SUBJECT: Forwards update to util revised response to IE Bulletin
 84-03, re final design of plant refueling cavity water seal.
 Seal provides redundant passive safety-related means of
 limiting refueling pool leakage.

Re: Turkey Point Units 3 and 4
Docket Nos. 50-250 and 50-251
IE Bulletin 84-03 (Revised Response)

AMENDED RESPONSE TO IE BULLETIN 84-03
"REFUELING CAVITY WATER SEAL"

**TURKEY POINT UNIT 4
REACTOR CAVITY SEAL
INTERIM DESIGN
FIGURE 1
FLORIDA POWER & LIGHT COMPANY
DATE 5/22/87
SCALE**

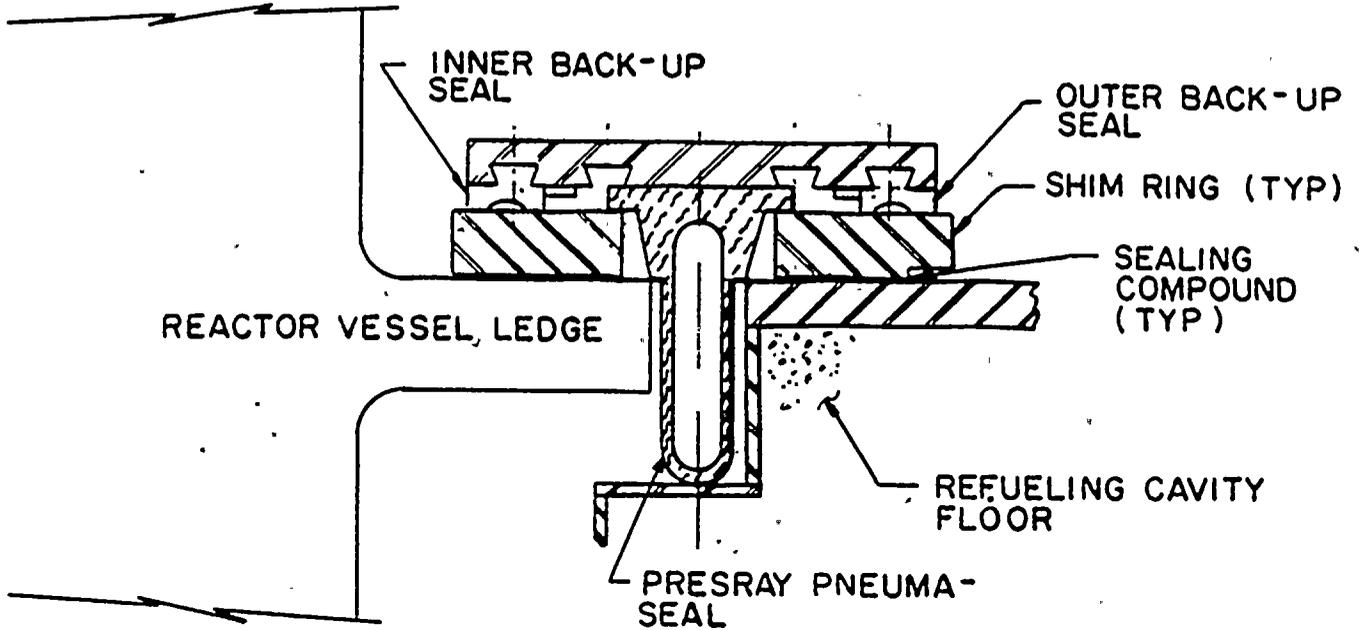
During the implementation of PC/M 85-94 in January 1986, a discrepant condition was discovered that required an interim design to be implemented. The interim design which was discussed in a previous Amended Response to IE Bulletin 84-03 submitted in March, 1986 installed shim rings to provide seating surfaces for the inflatable seal as well as the back-up seals. The interim design is shown in Figure 1.

TURKEY POINT UNITS 3&4
REACTOR CAVITY SEAL
REVISED DESIGN
FIGURE 2

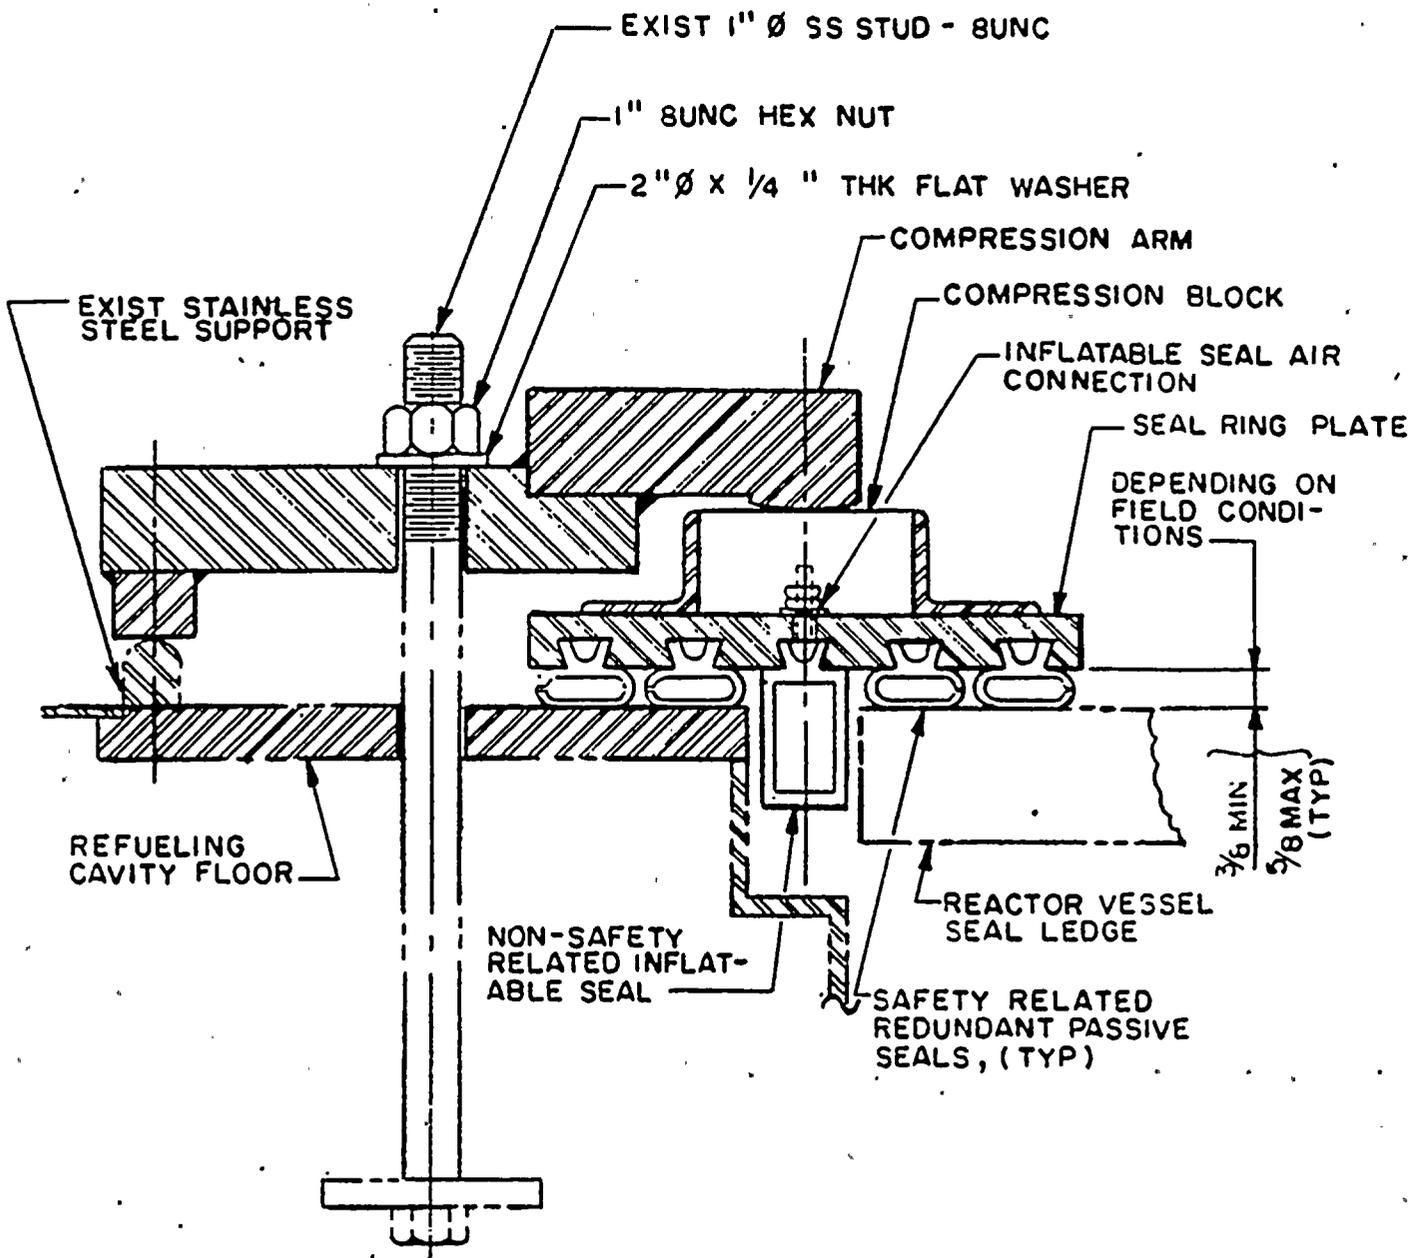
The revised design is shown in Figure 2. A new seal ring plate was fabricated from stainless steel to replace the original carbon steel seal ring plate. The new stainless steel plate was analyzed and stiffener members added to reduce stresses and deflection of the plate during lifting and while in place.

Measurements of the existing condition of the reactor cavity were taken and compression seals were designed and fabricated to provide a leaktight seal with the expected tolerance of the installed assembly. Two compression seals are provided on each side of the 2" annular gap comprising the reactor cavity and are affixed to the seal ring plate by dovetail retainers molded into the seal (which fit into dovetail grooves machined into the bottom of the seal ring plate.) The compression seals perform the safety function by providing a redundant passive means of limiting high volume losses (greater than 50 gpm) from the refueling pool. The acceptable leakage rate of 50 gpm is based on: a) The ability of the two 75 gpm reactor sump pumps to transfer this flowrate to the waste hold-up tank or refueling water storage tank; and, b) The acceptable rate of falling reactor cavity/spent fuel pit levels of less than two inches per hour allows for adequate operator response times to take corrective action. Although the maximum acceptable leakage rate has been set at 50 gpm, actual leakage past the seals is expected to be near zero based on previous experience with similar seals and based upon experimental and in situ testing.

Preload is applied to the compression seals via compression arms that act on the top of the seal ring plate. The compression arms are torqued to a predetermined value that will deflect the compression seals into their operating range around their entire circumference.

An analysis was performed on the compression seals to determine margin of safety against failure. Considering the preload obtained from the compression arms and hydrostatic forces, the compression seals have a margin of safety of at least 4.68 against failure. In addition, the compression seals were tested by the vendor at up to 30 psig equivalent static water pressure, a factor of safety of at least 2.77, without leakage.

An inflatable seal is also provided to perform the non-safety related function of minimizing leakage in accordance with ALARA considerations. The inflatable seal is also affixed to the seal ring plate by dovetail retainers molded onto the seal which fit into dovetail grooves machined into the bottom of the plate. When the plate is installed, the inflatable seal hangs into the 2" annular gap between the reactor vessel flange and refueling cavity ledge. When inflated to its operating pressure of 30 to 35 psig, the inflatable seal expands to form a seal against the wall of the reactor cavity and the reactor vessel flange to stop any leakage that may have passed the compression seals.

TURKEY POINT UNITS 3 & 4
REACTOR CAVITY SEAL
SEAL PRESSURIZATION SYSTEM
FIGURE 3
FLORIDA POWER & LIGHT COMPANY
DATE 5/22/87
SCALE

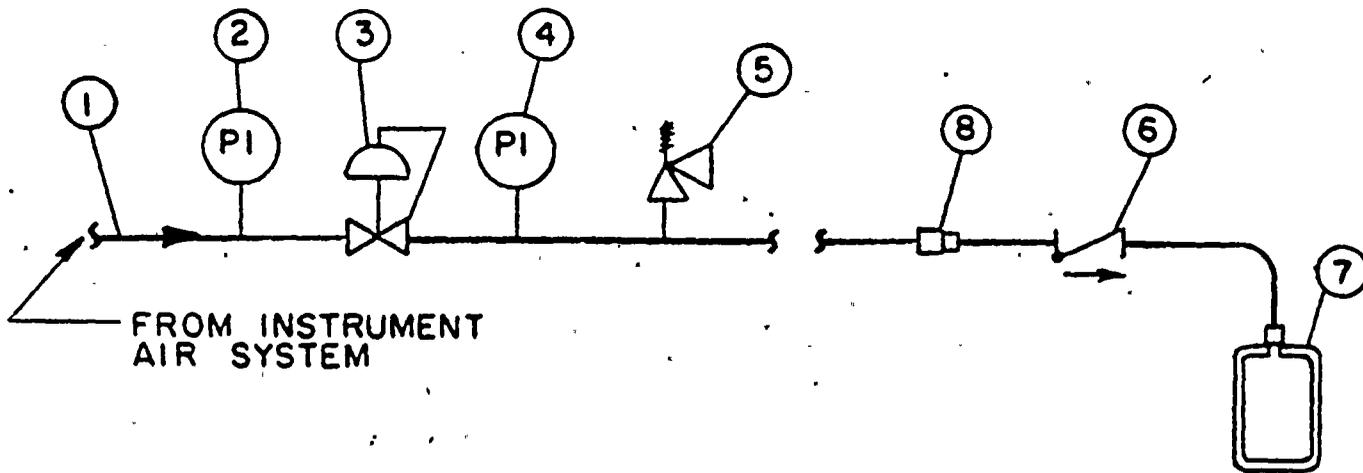
The inflatable seal is pressurized using plant instrument air. The seal pressurization system is shown in Figure 3. The system includes a pressure regulator to control air pressure to the seal, local pressure indication upstream and downstream of the regulator, a relief valve sized to handle flowrates that will be experienced in the event of a regulator failure and a check valve to maintain the seal in the inflated condition should air supply pressure be lost. A failure modes analysis was performed on the inflatable seal and concluded that no potential failure mode of the inflatable seal will have an adverse effect on the safety related compression seals.
